**METROPOLITAN GOVERNMENT OF NASHVILLE AND DAVIDSON COUNTY**

**STAFF RECOMMENDATION**  
**1114 Lillian Street**  
**February 19, 2014**

**Application:** New construction - infill  
**District:** Lockeland Springs-East End Neighborhood Conservation Zoning Overlay  
**Council District:** 06  
**Map and Parcel Number:** 08313013600  
**Applicant:** Jeff Zeitlin, Martin Construction  
**Project Lead:** Sean Alexander, sean.alexander@nashville.gov

GRADING SITE PLAN  
 1114 LILLIAN STREET  
 A HORIZONTAL PROPERTY REGIME  
 WITH PRIVATE ELEMENTS

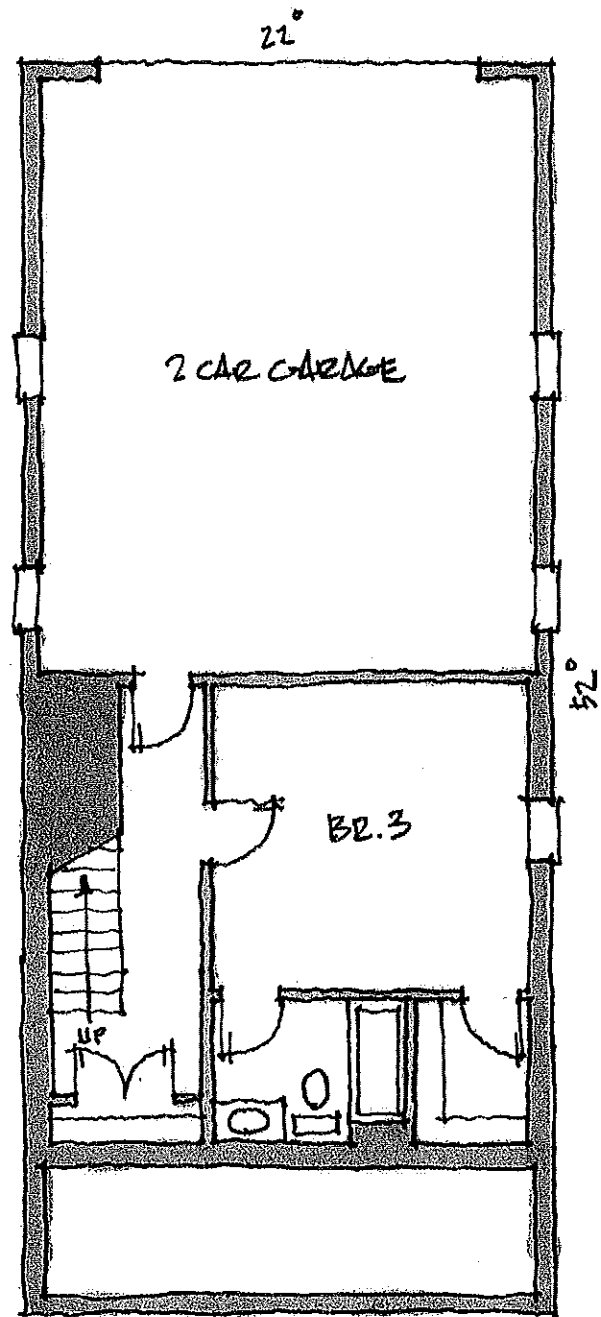
The building will be located with the front edge in line with adjacent structures, between eighteen and twenty feet (18' - 20') from the street, which is an appropriate setback. The building's side setbacks will be approximately five feet (5') on each side. This meets bulk zoning requirements and is consistent with the rhythm established by existing houses on the street. Staff finds that the project will meet guideline II.B.1.3.

The location of the HVAC and other utilities was not indicated on the drawings. The HVAC should be located on the rear façade or on a side façade beyond the midpoint of the house in order to meet section II.B.9.

**1112 & 1114 Lillian Street Infill Project**  
**Rear Elevation and Left Side Elevation**

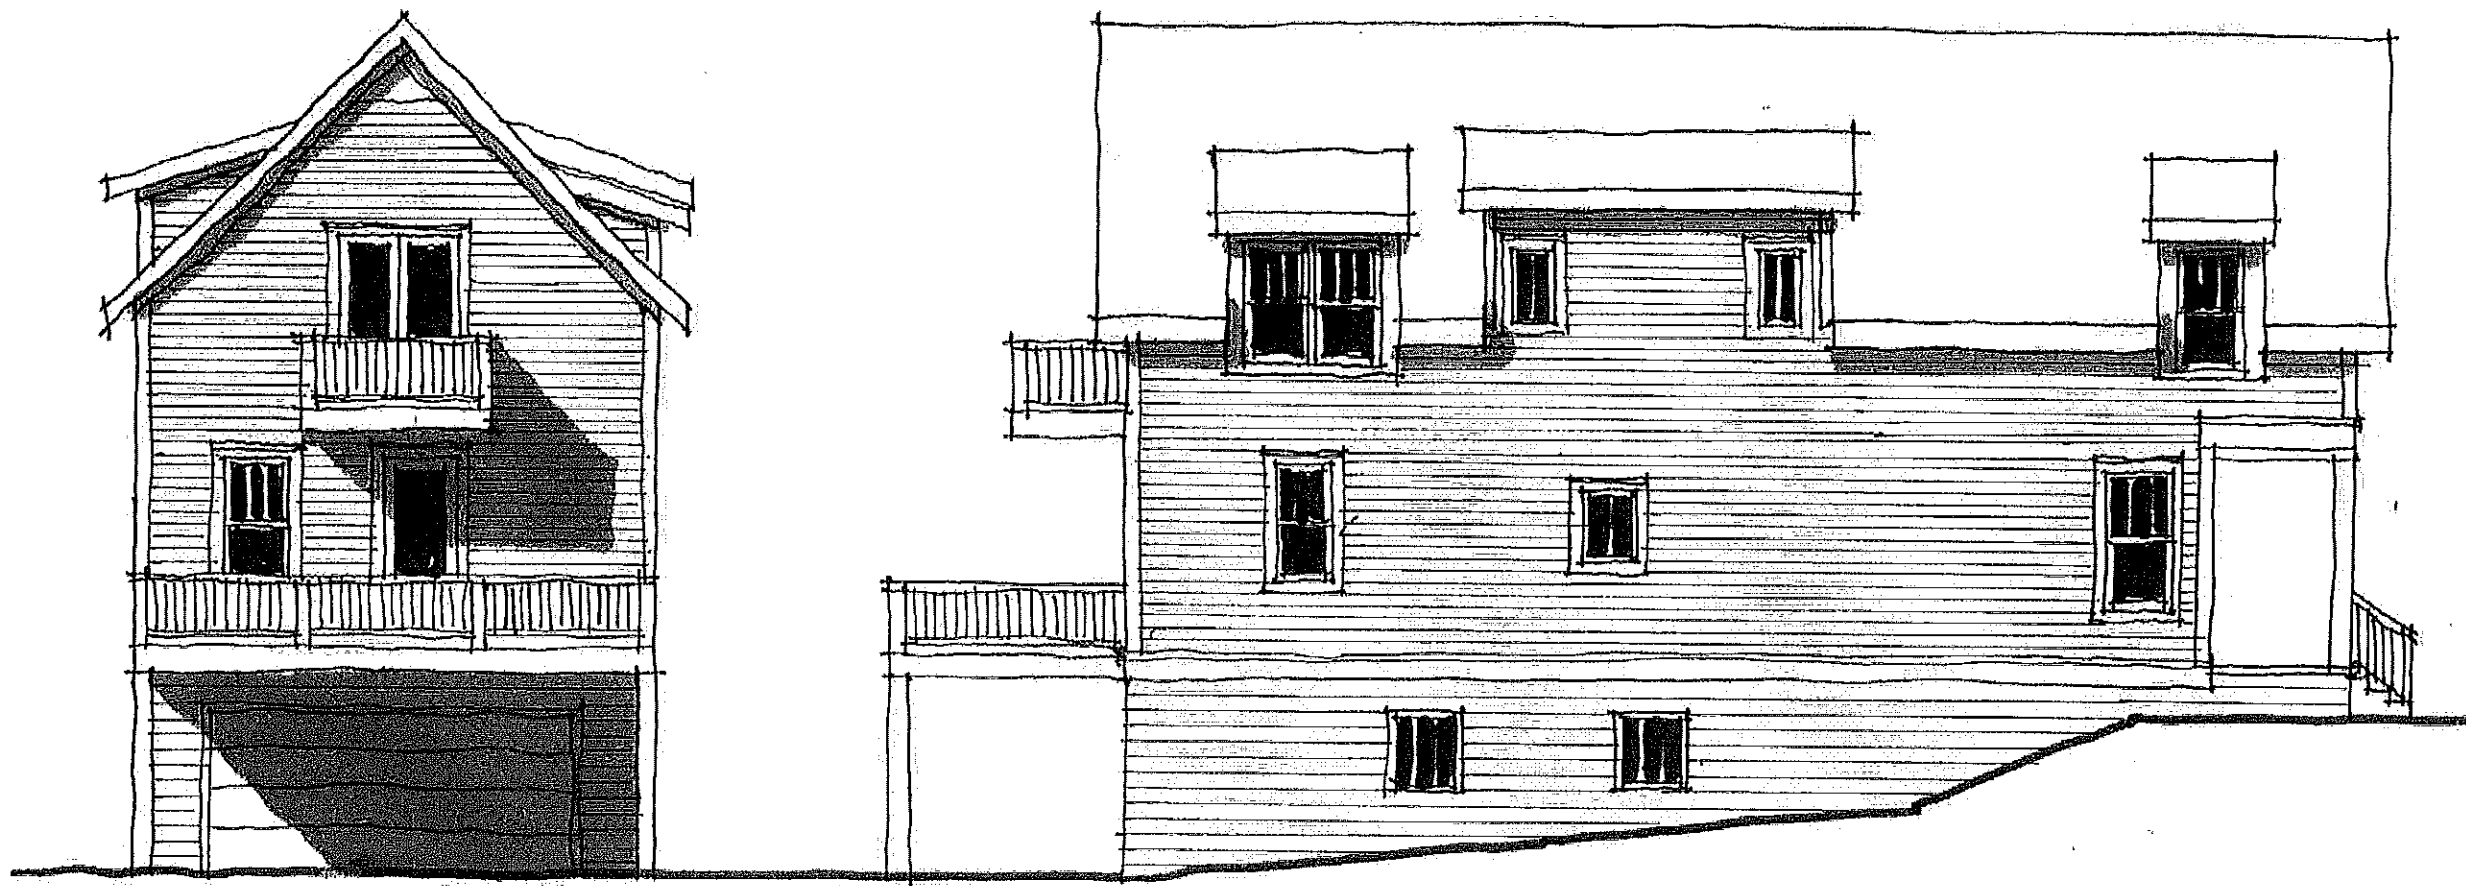
The windows on the house will be generally twice as tall as they are wide, and the first story windows will be taller than those on the upperstory. With the exception of a section on wall on the left side, there will be no expanse greater than ten feet (10') without an opening. Typically, historic houses have a no more than eight to twelve feet (8' – 12') of wallspace between window openings. Staff finds that with the addition of a window on the left side of the house, the proposal will meet guideline II.B.7.

- A window is added to the left side of the building;
- That the drawings are revised to call out dimensions and materials.
